Re: **Technical Response Letter**
4901, 4915, 4919, 4921, 4939, and 4945 Broadway;
Parcel No. 013-1136-008-04 (no address);
311 and 313 51st Street;
4974, 4970, 4966 and 4964 Desmond Street;
Oakland, California

Re: **Technical Response Letter**
4901 Broadway and 4974, 4970, 4966 and 4964 Desmond Street
Oakland, California
ACDEH Case No. RO0003186
GeoTracker Global ID T0000007664

On behalf of US TP SRM Temescal, LLC, PANGEA Environmental Services, Inc. (PANGEA) prepared this technical response letter to provide clarification requested by the agency letter dated November 29, 2017. The letter requests clarifications for two remaining uncertainties detailed below.

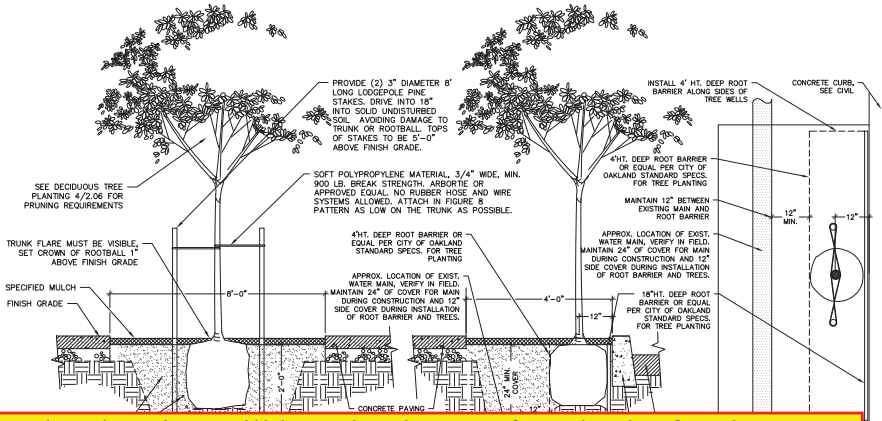
This sloped face of soil is regraded native placed up against the shoring. This native soil is outside the building footprint., and was later removed to allow compaction as shown on subsequent photographs herein.

The sloped native soil is still in place here. We are now standing wall forms which outline the building walls in this area. Our intent at this point is still to leave the native soil in place and import other fill material after the walls have been poured.

After the building walls were poured we learned that we could not fill the triangular space between the building wall and the native sloped material due to compaction issues. This resulted in all of the native soil being removed from the bottom up in stages. A section of the slope measuring about 6'-0" wide was cut away at the bottom and this soil was used to fill the void at the bottom seen here. This continued until the native soil was gone which brought the grade up to about 8'-0" below the sidewalk.

Now that the native soil was gone, we completed the back fill with imported gravel.

PERMIT RESUBMITTAL
 LANDSCAPE PLAN
 - AT GRADE

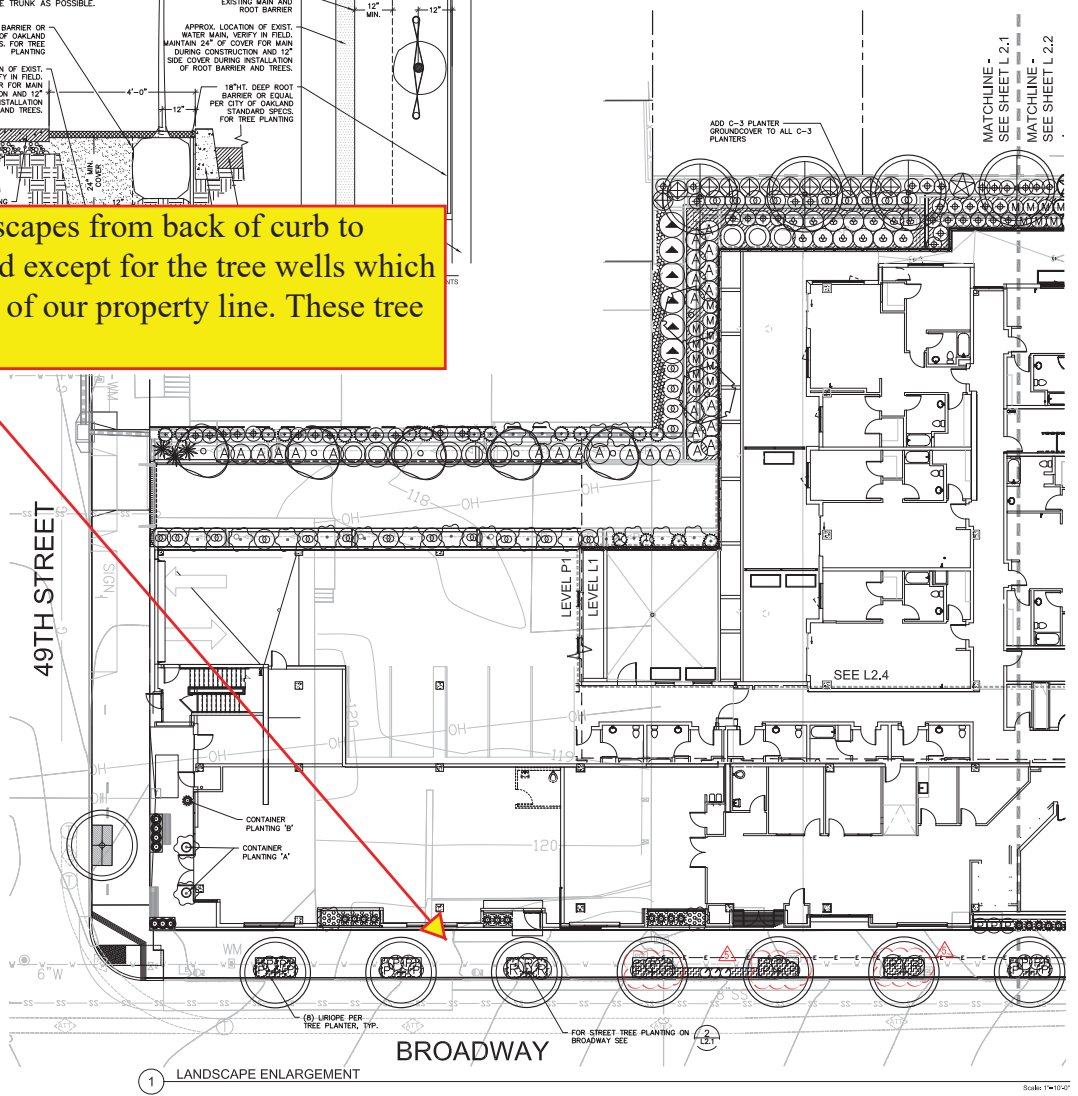
As shown on annotated photographs in Appendix A, there will be no exposed soil along Broadway which encompasses the area of concern. The small planters are lined and above grade, and will be filled with landscape soil/topsoil. The public right of way will have new concrete sidewalks poured.

The completed project will have hardscapes from back of curb to building wall. No soils will be exposed except for the tree wells which are located in the right of way outside of our property line. These tree wells will have 12" of new topsoil.
